Proposal Request

Stanton Elementary School
870 W. College Avenue
Stanton, KY 40380

Proposal Request Number: 001

Subject: **Drainage Addendum #2 Letter
Powell County Elementary
Stanton, Powell County, Kentucky
Solid Ground Project No.: 24-173**

SD2.9
PR#1

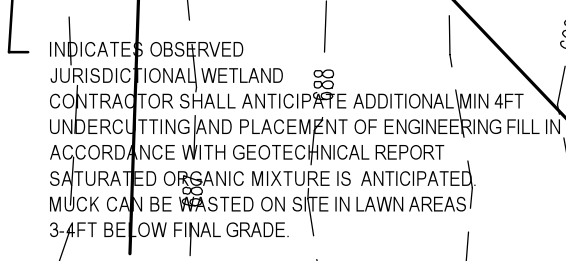
Please provide itemized pricing to install the wick drains in accordance with the Geotechnical Engineer /Testing Agency Addendum #2 letter dated 3-28-24.

Attachments: SD2.9 Wick Drain Layout Plan, and Solid Ground Drainage Addendum #2 Letter dated 3-28-24

Figure 1 - Approximate Locations

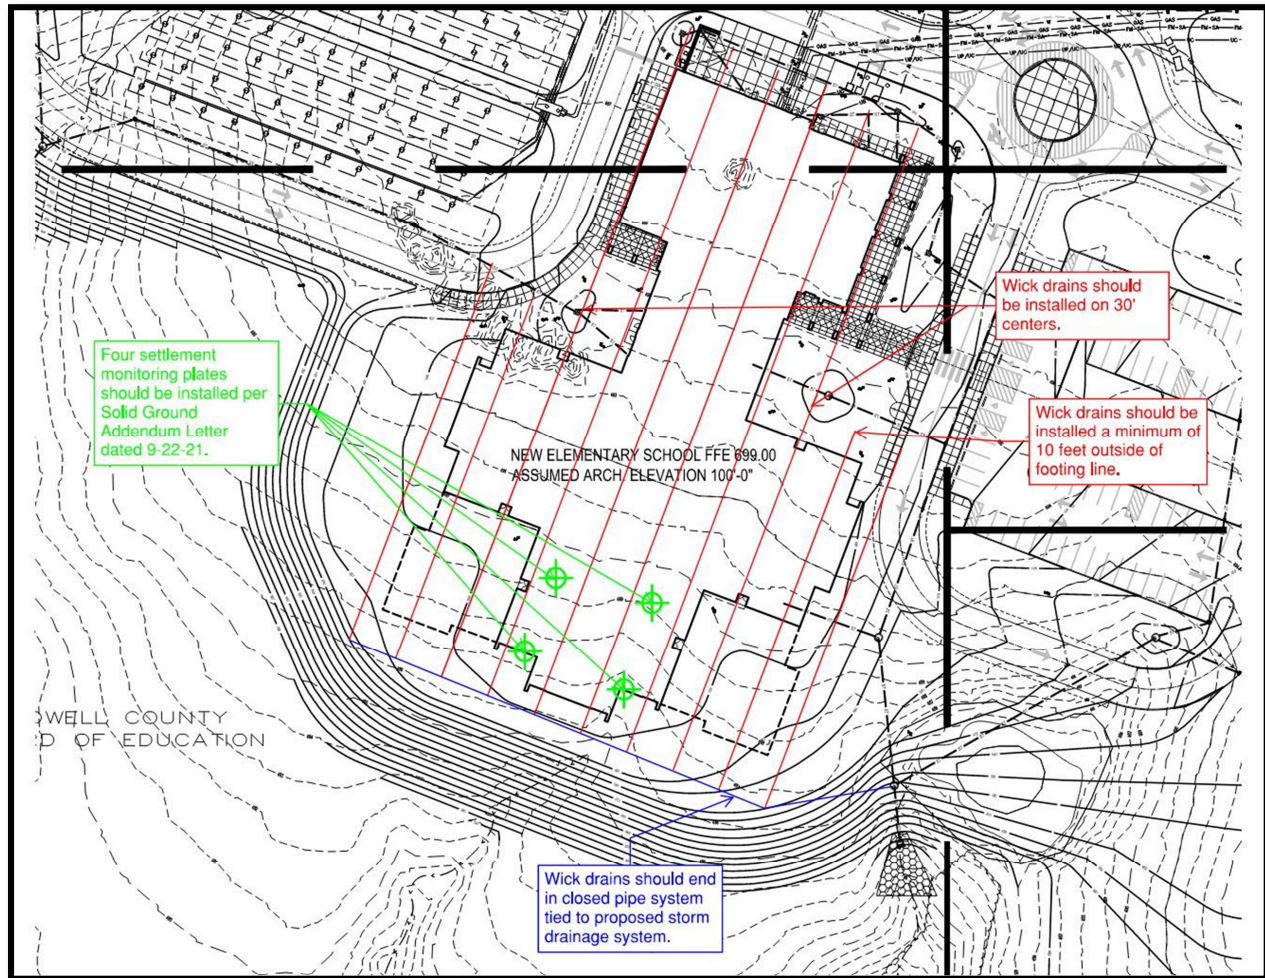
Due to the high in-situ moisture content of the subgrade soils and the known 10+ feet of fill, we are recommending a modified wick drain implementation. The wick drains will assist in dewatering the site and aid in consolidation of the proposed fill soils.

Wick drains should consist of a 4" perforated pipe that is wrapped in filter fabric. Wick drains should be embedded with a minimum of 6" of open grade stone (#57 to #8). Wick drains should be installed a minimum of 3 feet into existing grade or the width of the nearest footing, whichever is greater. Wick drains should be installed with 30 feet spacings and should extend a minimum of 10 feet past the outside edge of footings. The wick drains should end into a closed pipe that is tied into the proposed storm drainage system. Figure 1 shows the approximate locations of wick drains, drain lines, and settlement monitoring plates.
